REPORT SUMMARY

REFERENCE NUMBER: (A) 24/504650/REM (B)24/504651/REM

ADDRESS: 5 Tonbridge Road, Maidstone, ME16 8RL

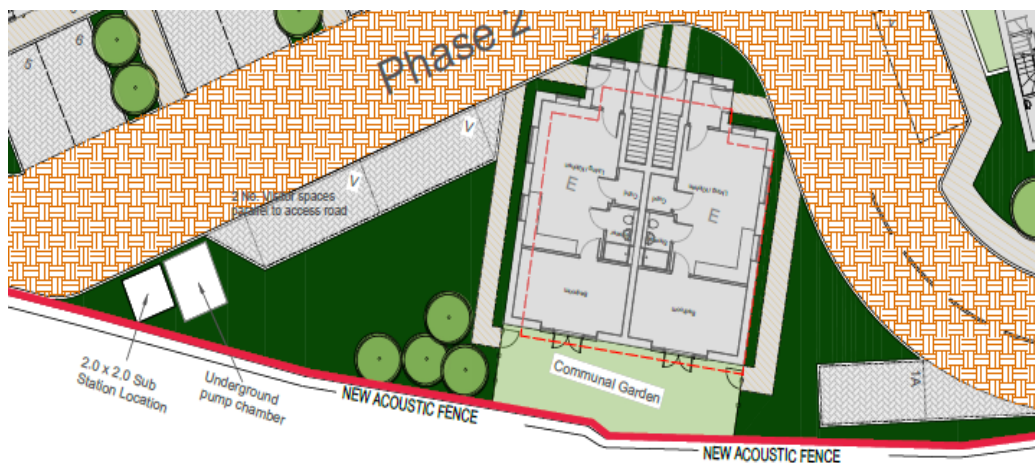
- 2.01 Phase 2 has Reserved Matters approval for 17 terraced, 2 semi-detached houses and 4 maisonettes. This application seeks a different scheme only in regard of the maisonette block (units 1A, 1B, 2A, 2B) which lies on the southeastern boundary with the train station.

- 2.02 This application proposes a slight repositioning forward of the block and slightly enlarged maisonettes (net gain of 33.3 sqm) so that internally it complies with nationally described space standards (NDSS). The footprint of the main building would increase by 1.1m in width and by 0.45m depth. The front gable includes porch lobbies which also need to be larger internally to meet NDSS. The overall result is that the gable increases marginally in size by 0.7m width and 0.4m depth. The overall impact on the maisonette block of these changes is a 0.3m increase in ridge height.

- 2.03 Due to the larger footprint, it also proposes a change in providing a shared garden area for the 4 maisonettes instead of 4 small private gardens. This will allow more publicly visible green amenity areas able to be created around the block.

- 2.05 This application makes identical changes to the maisonette block as described above. It also proposes to replace 5 perpendicular parking spaces next to the block with 2 parallel parking spaces. This will allow more soft landscaping and green amenity areas to be created around the apartment block.
- 2.06 An acoustic fence to the railway land will be installed on the boundary.
